Intersection ID: 7207	Main Street: HOPE_VALLEY_LN	Cross Street: KINGVILLE_DR	Location:	W
ADA ID: C1E31040BB08	Ramp Type: BlendTrans1	Initial Pass/Fail: Fail	Overall Compliance: No	Severity Score: 21.25

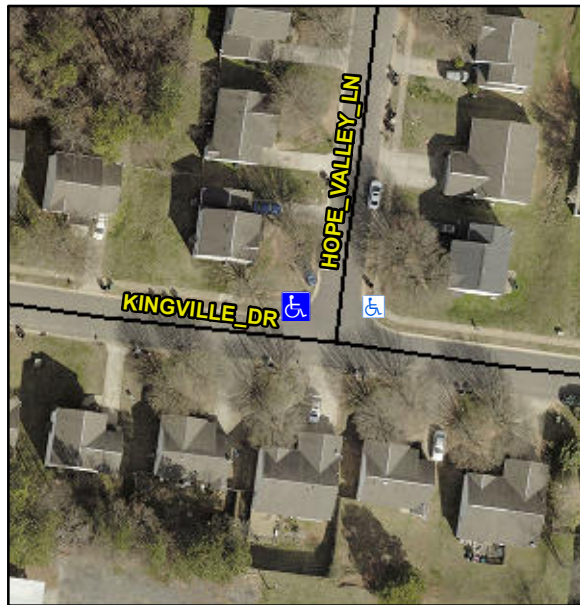
R304.5.1, R304.5.3

Compliance	Description	Data	Compliance	Description	Data
N/A	Ramp Length (in)	12.0	Yes	BlendTrans Slope (%)	0.5
No	Ramp Width (in)	42.0	No	BlendTrans XSlope (%)	5.8
N/A	Flare Type LT	N/A	N/A	Flare Type RT	N/A
N/A	Flare Slope LT (%)	N/A	N/A	Flare Slope RT (%)	N/A
N/A	Flare Traversable LT?	N/A	N/A	Flare Traversable RT?	N/A
N/A	Landing Length (in)	N/A	N/A	DWS Provided?	N/A
N/A	Landing Width (in)	N/A	N/A	DWS Contrast?	N/A
N/A	Landing Slope (%)	N/A	N/A	DWS Length (in)	N/A
N/A	Landing X Slope (%)	N/A	N/A	DWS Full Width?	N/A
N/A	Landing Curb? (Y/N)	N/A	N/A	DWS Offset (in)	N/A
N/A	Shared Landing?	N/A			
N/A	Gutter Ponding?	N/A	N/A	Gutter Slope (%)	N/A
N/A	Gutter Lip Ht (in)	1.0	N/A	Gutter X Slope (%)	N/A
N/A	Painted X Walk1?	No	N/A	Painted X Walk2?	N/A
	X Walk 1 Direction	To E		X Walk 2 Direction	N/A
	X Walk 1 Width (in)	N/A		X Walk 2 Width (in)	N/A
	X Walk 1 Slope (%)	8.2		X Walk 2 Slope (%)	N/A
	X Walk 1 X Slope (%)	2.9		X Walk 2 X Slope (%)	N/A

N/A	Ramp inside XWalk1?	N/A	N/A	Ramp inside XWalk2?	N/A
	Road Slope (%)	2.9		Clear Space?	N/A
	Road X Slope (%)	8.2	N/A	Clear Space to XWalk (in)	N/A
N/A	Any Obstructions?	N/A	N/A	Storm Grate/Utility Hazard?	N/A
	Obstruction Type			Storm Grate/Utility Type	
		N/A			N/A
			Yes	Surface Condition? (G/P)	Good
			N/A	Curb Slope (%)	1.6

Remove & Replace Curb Ramp With Two New Directional Ramps or Equivalent.
